Historic Landmarks and Preservation Districts Commission

Report to the Committee

Case No: 23-COA-0054
Classification: Staff Review

Property Address: 1436 S. Brook Street

Figure 1. 1928 Sanborn Fire Insurance Map (Vol. 5, Sheet 529).

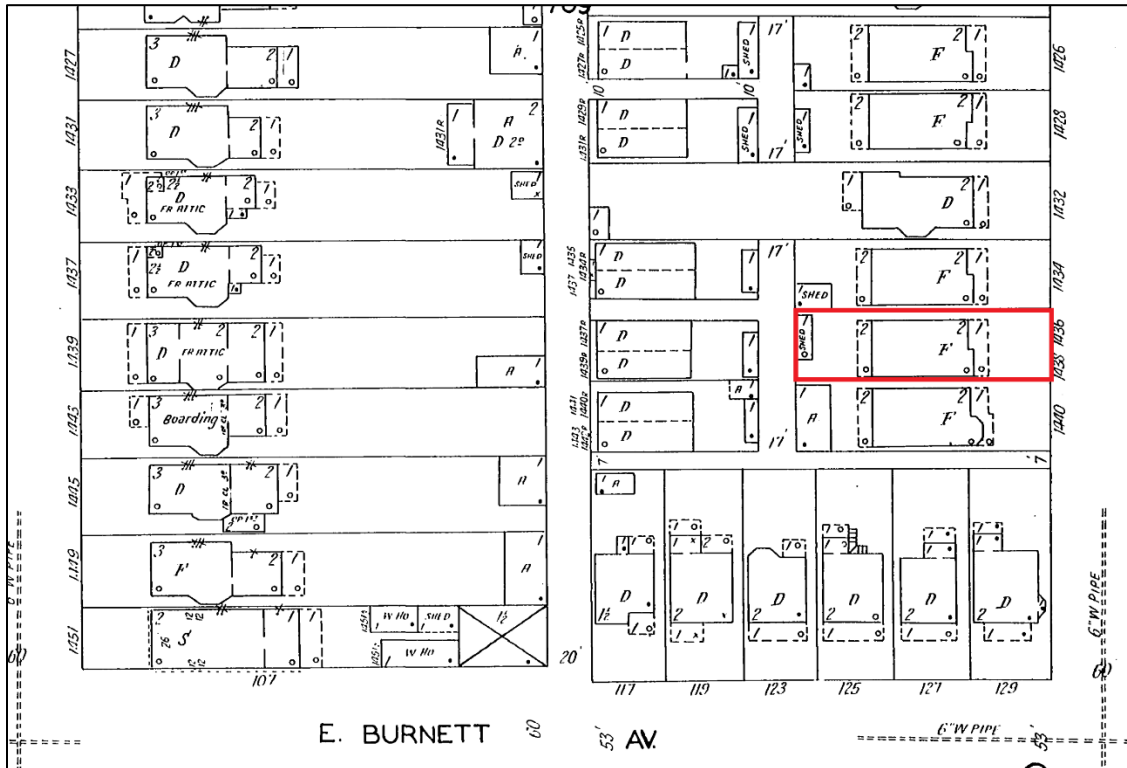
The property is located on the west side of S. Brook Street three lots north of E. Burnett Street. The house is zoned TNZD and located within the Traditional Neighborhood Form District. The two-story, frame Colonial Revival Style house, built circa 1910, was historically a duplex (**Figure 1**). The 1920 Sanborn Map shows the building with two addresses and it's labeled as "F" for Flat, which mean more than one dwelling unit. The right side of the building, known as 1436 S. Brook, was the upstairs flat. The left side, known as 1438 S. Brook, was the downstairs flat. Real estate ads in the *Courier-Journal* from 1910 and on show the two separate flats. Furthermore, the architecture and form of the building clearly shows that it was built as a duplex.
